### **Crankshaft Replacement Notice**

For the Stolle Ragsdale Bodymaker  
January 2008

The crankshaft assembly of a Stolle Ragsdale Bodymaker with the two halves indicated

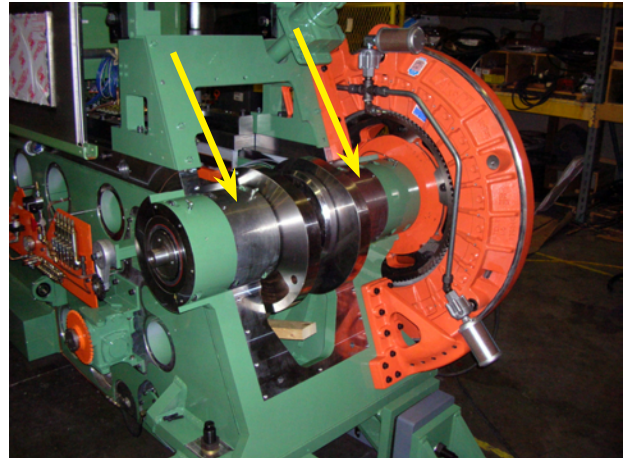
The crankshaft assembly for a Stolle Ragsdale Bodymaker is comprised of two halves - and that can lead to a practice that seems correct, but is not. When replacing either side of the crankshaft, both halves **MUST** be replaced as a set. Of course, the two crank halves should have a matching stroke length, but in addition, the cams should be a matched set to ensure the redraw pressure is even on the redraw stroke. The even redraw pressure created by matched cams is critical to production of good, consistent can bodies.

Closer view of the redraw cams on the crankshaft assembly that must have matching serial numbers.

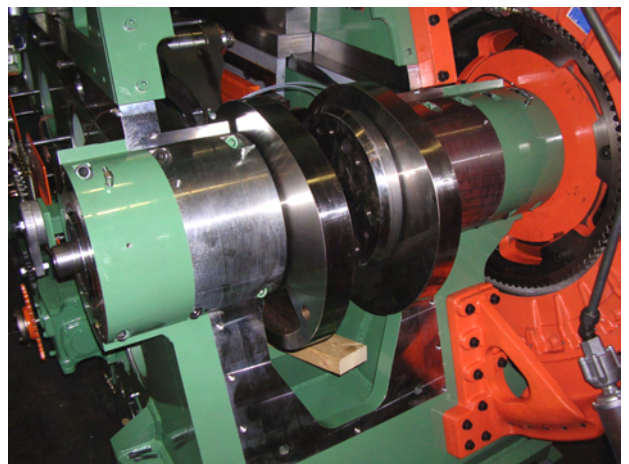
In some cases, Stolle has made revisions to the cam profiles which can affect the redraw pressure. The only way to ensure that the cams on both crank halves match is to check the serial numbers. Even if the part numbers match, the cams on each half **MUST** have matching serial numbers.
